SUBJECT: Savannah River Site's Responses to the Regulatory Comments on the Effectiveness Monitoring Report (EMR) for the C-Area Groundwater (CAGW) Operable Unit (OU) Removal Action (U) - July 2023 through June 2024 (SRNS-RP-2024-01334, Revision 0, November 2024) SEMS Number: 82

SRS Response to the U.S. Environmental Protection Agency's Comments on the Effectiveness Monitoring Report (EMR) for the C-Area Groundwater (CAGW) Operable Unit (OU) Removal Action (U) - July 2023 through June 2024 (SRNS-RP-2024-01334, Revision 0, November 2024) SEMS Number: 82

Figure CR-1 (Revised Figure 2). CAGW OU TCE Plume 4Q23

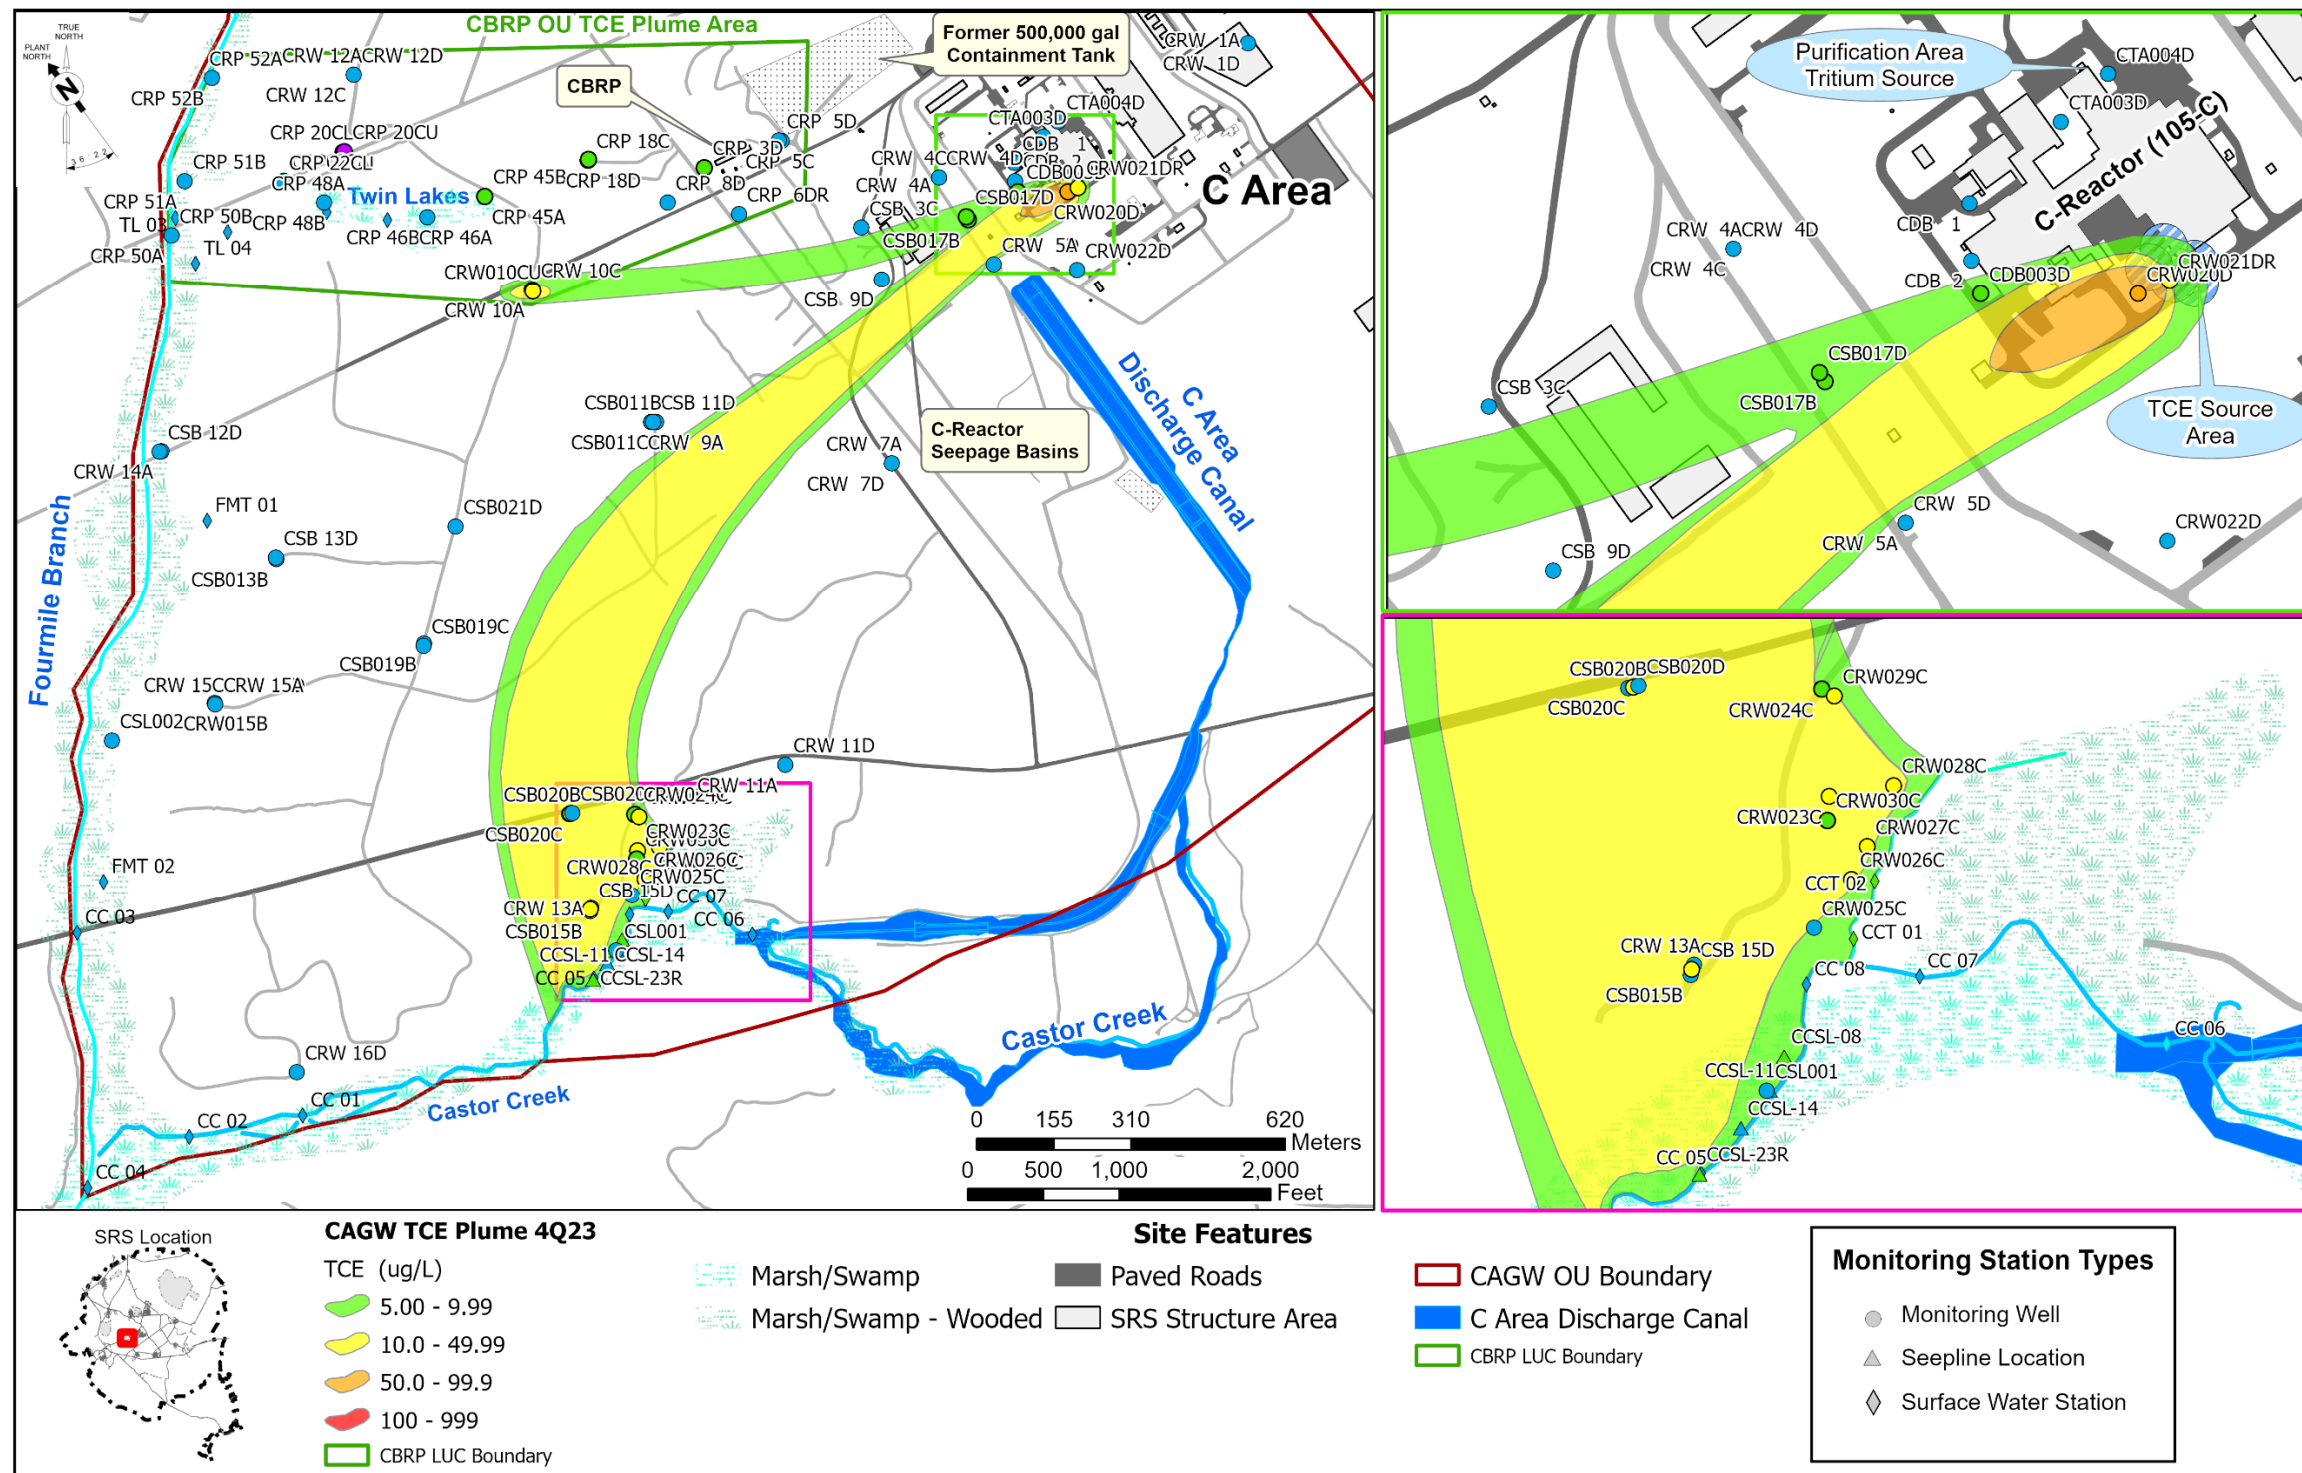
1. The locations of the wells shown on Figure 2 (CAGW OU TCE Plume 4Q2023) and Figure 7 (CAGW OU Monitoring Stations) are not consistently and clearly labeled, such that several wells discussed in the EMR could not be located. For example, Section 3.4.2.1 (Trichloroethylene [TCE]) discusses monitoring well CRW021DR as a source area well, but this well is not identified in the TCE source area on Figure 2 (i.e., in the top right box). In addition, Figure 7 indicates well CRW021DR is the eastern source area well, but Figure 2 identifies the easternmost well as CRW020D. As another example, Section 3.4.2.2 (Tetrachloroethylene [PCE]) discusses monitoring well CRP 5C with the maximum concentrations of PCE, but this well is not identified on Figure 2. *Please revise Figures 2 and 7 to clearly and consistently label the locations of the wells discussed in the EMR.*

Response: Agree

Please refer to attached Figure CR-1 (revised Figure 2) for correct identification of the monitoring well locations and labels. Figure 2 has been corrected to show monitoring well CRW021DR in the TCE source area, well CRW021DR as the eastern source area well, and the inclusion of monitoring well CRP 5C consistent with Figure 7.

Future CAGW OU groundwater reports will ensure the monitoring wells discussed in the text are consistently identified in the figures. No changes are proposed to the current report.

Figure CR-2 (Revised Figure 9). MAZ Water Elevations Near Castor Creek

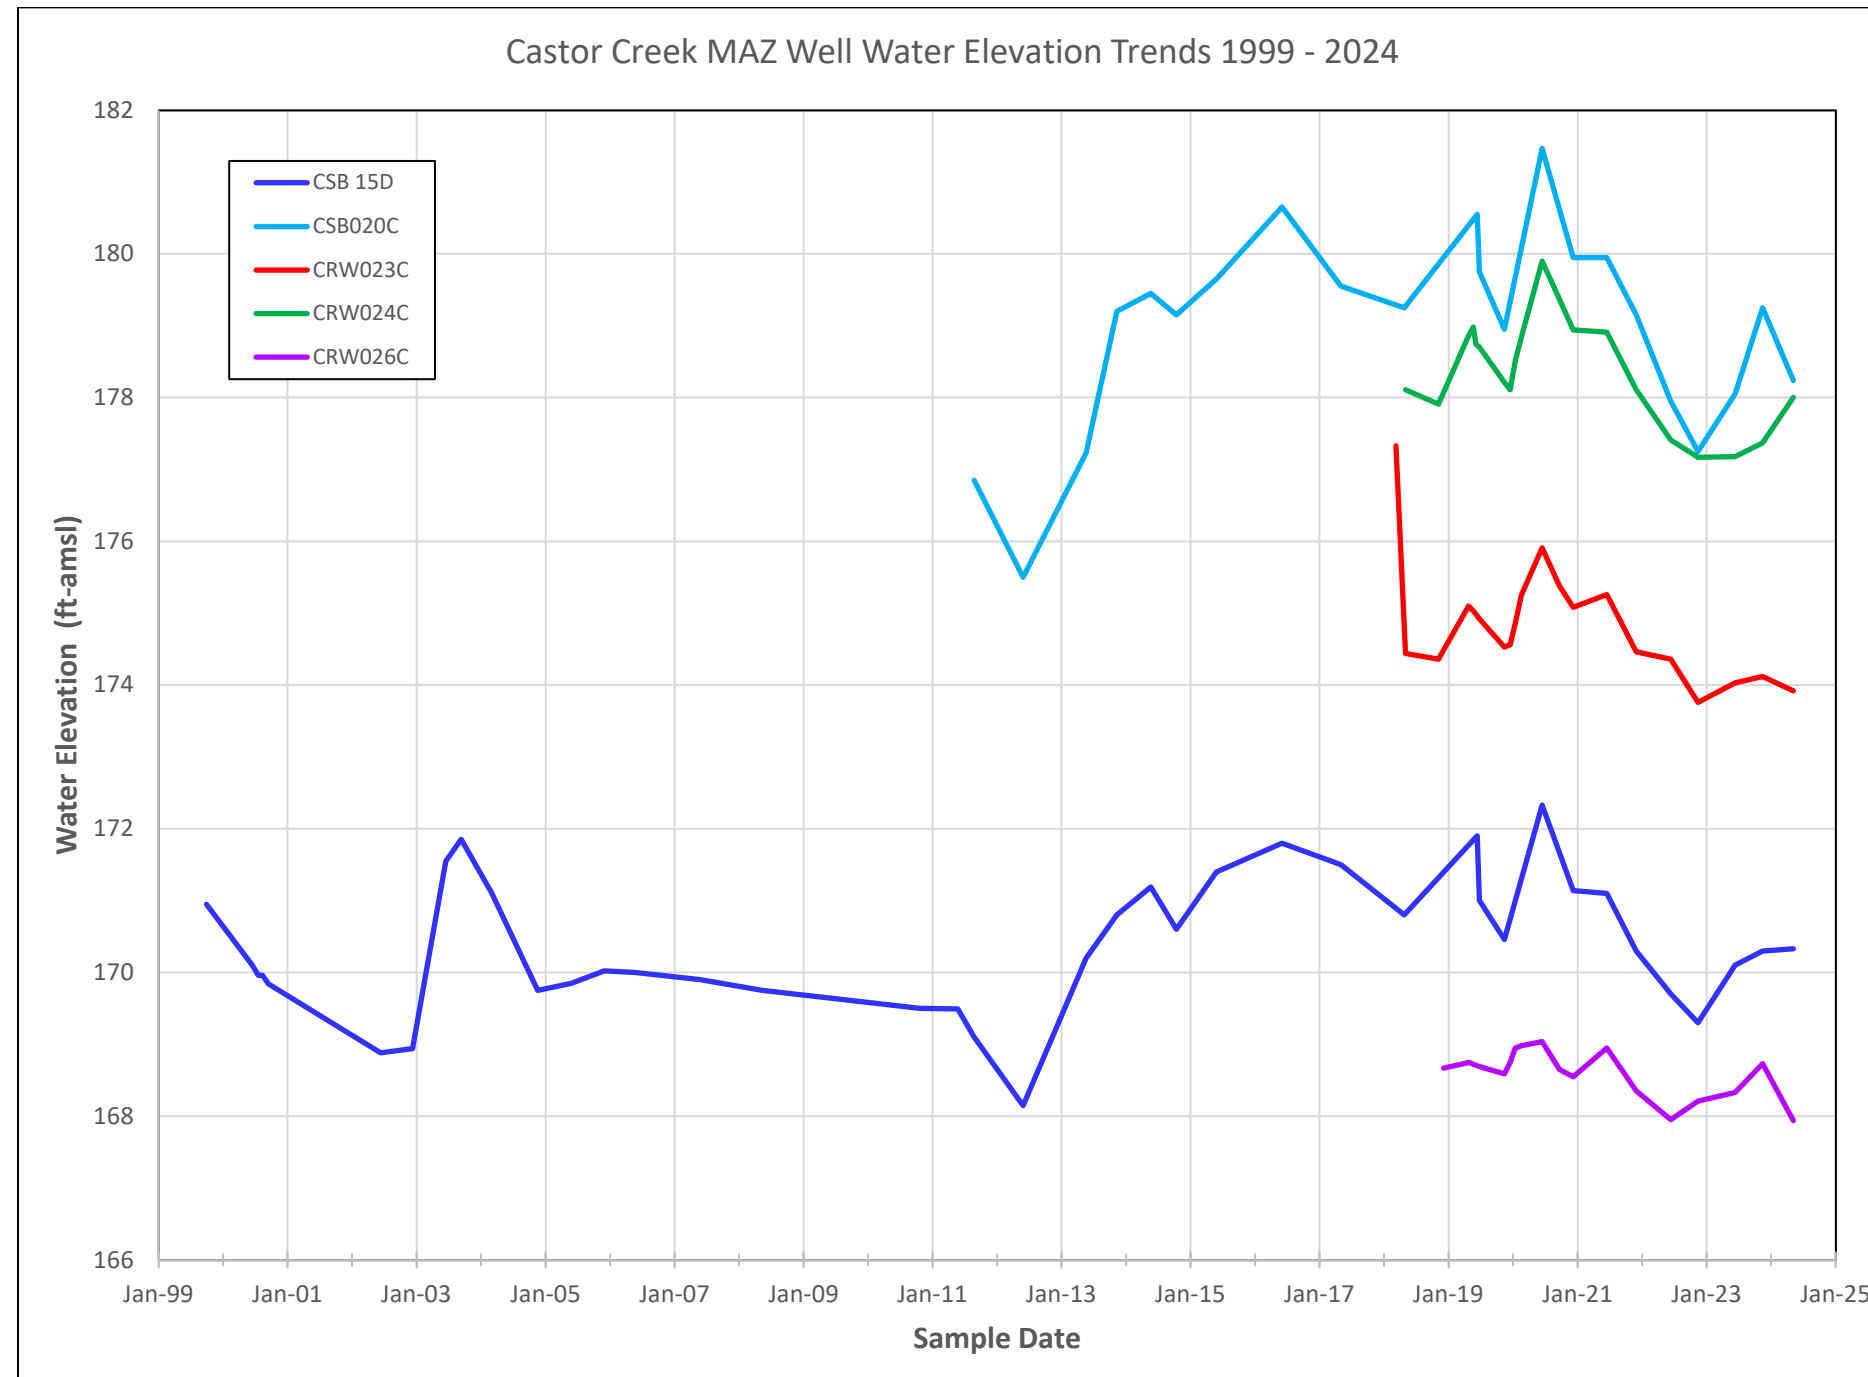
1. **Section 3.2, Groundwater Elevation Measurements and Groundwater Flow Direction, Page 9 of 118, and Figure 9, Water Table Trends Near Castor Creek, Page 44 of 118:** The text identifies the June 2020 groundwater elevation for CSB 15D as 52.5 meters (172.36 feet) above mean sea level (amsl), but Figure 9 indicates the highest water elevation for CSB 15D in 2020 was over 175 ft amsl. *Please revise the text and Figure 9 to present consistent information for the groundwater elevation at CSB 15D.*

Response: Agree.

The text correctly identifies the June 2020 groundwater elevation for CSB 15D as 52.5 meters (172.36 feet). Please refer to attached Figure CR-2 (revised Figure 9) that shows the correct June 2020 groundwater elevation for CSB 15D.

Figure CR-4 (Revised Figure 17). Ethylene Groundwater Trends

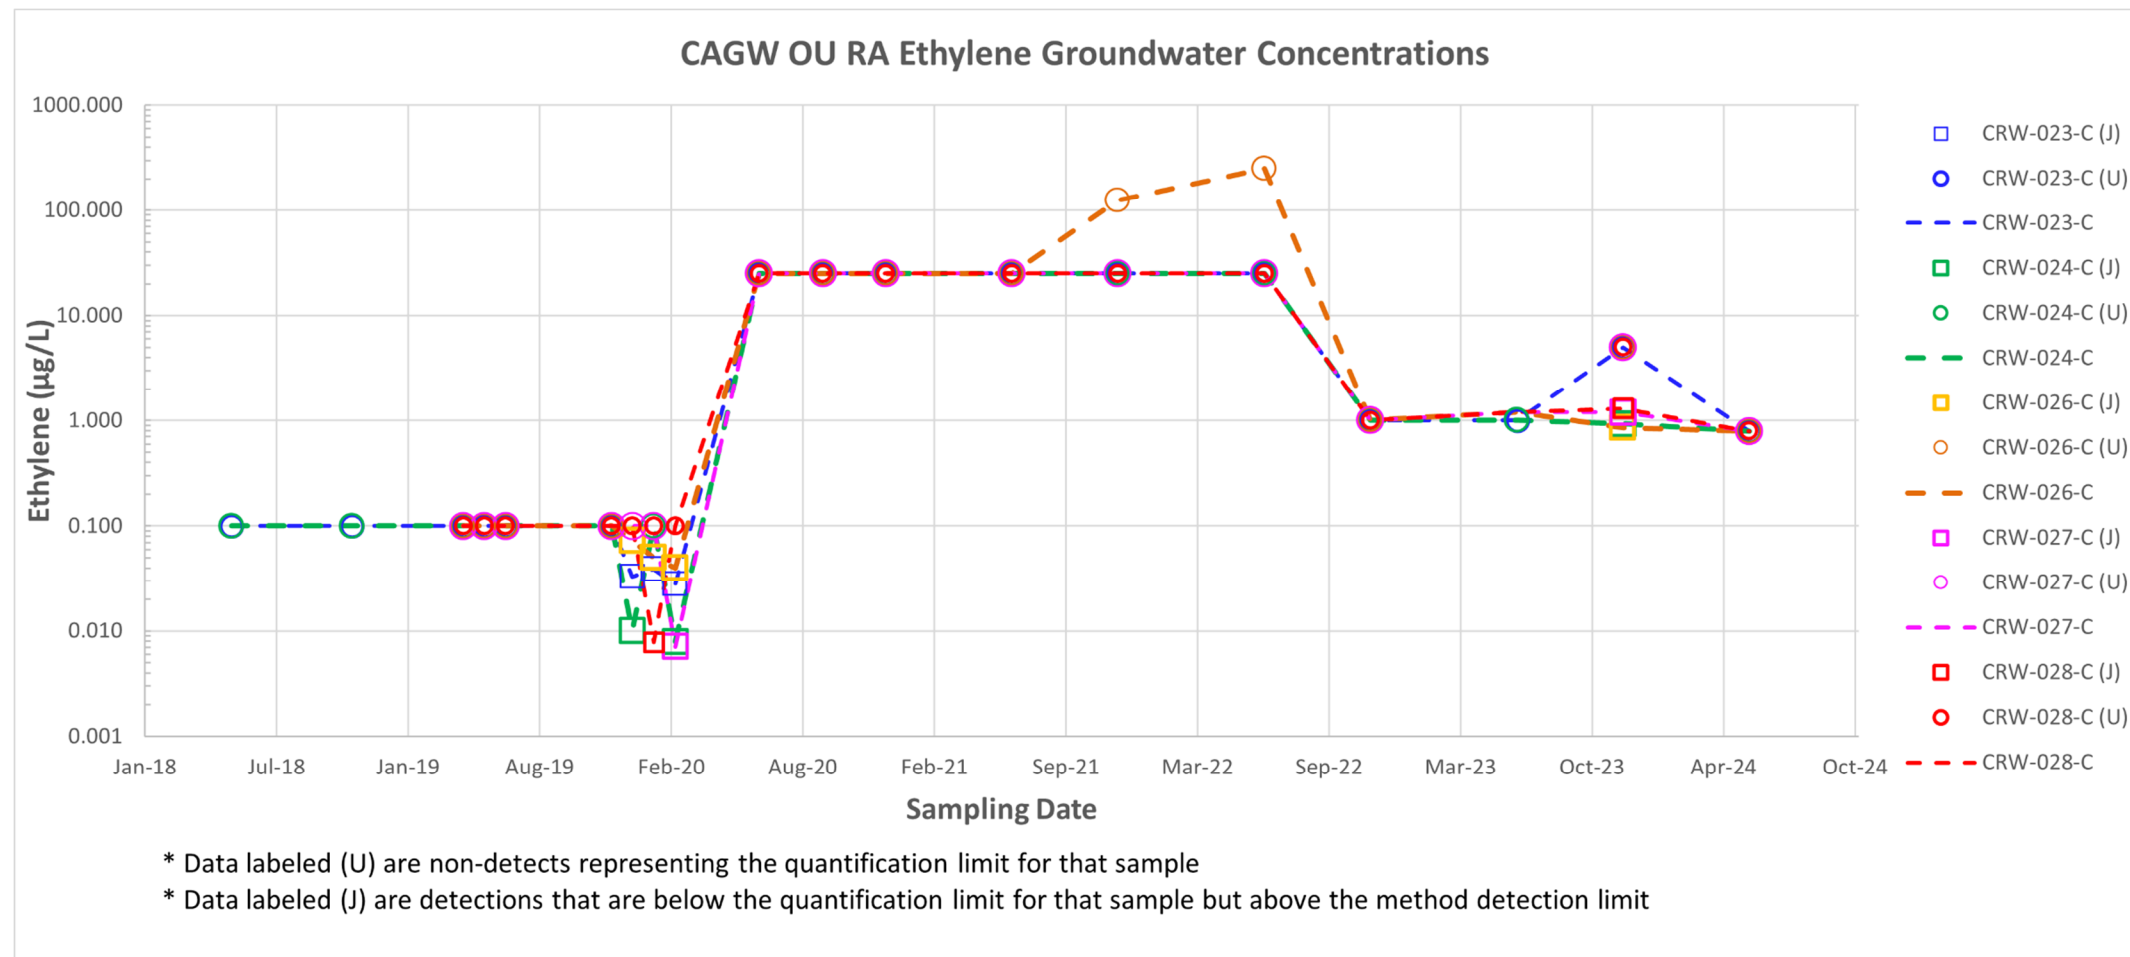
- 2. Section 3.4.1.5, Ethylene, Pages 17 to 18 of 118, and Figure 17, Ethylene Groundwater Trends, Page 52 of 118:** The text reports concentrations for ethylene during the 4Q23 sampling period that are inconsistent with Appendix A (CAGW OU NTC RA Analytical Data 2023-2024). The text states that ethylene concentrations in the wells were between 0.92 micrograms/liter ($\mu\text{g/L}$) to 1.3 $\mu\text{g/L}$, but Appendix A only reports one detection of ethylene (0.92 $\mu\text{g/L}$) in well CRW024C. The text also reports the highest ethylene concentration at seepline location CCSL-023R as 23.1 $\mu\text{g/L}$, but Appendix A reports an ethylene concentration of 7.5 $\mu\text{g/L}$ at this location. In addition, Figure 17 presents misleading information for ethylene concentrations detected in groundwater, as the trend lines representing ethylene concentrations do not differentiate between the not detected (ND) and the detected results (e.g., using solid vs. open circles as symbols for each data point). Based on Figure 17, ethylene appears to increase in 2020 and then decrease in 2022; however, the text indicates the changes in concentration are due to elevated method detection limits (MDLs). *Please revise the discussion of ethylene concentrations in Section 3.4.1.5 to be consistent with Appendix A. Also, please revise Figure 17 to differentiate between the detected and not detected results.*

Response: Agree.

The text correctly identifies the Ethylene concentrations for 4Q23 sampling period. Please refer to attached Figure CR-3 (revised Appendix A) that shows the correct 4Q23 groundwater concentrations. As requested, Figure CR-4 (revised Figure 17) is also attached with the non-detect data clearly labeled. It can be observed that most of the data are either J or U qualified due to the high quantitation limits for the samples.
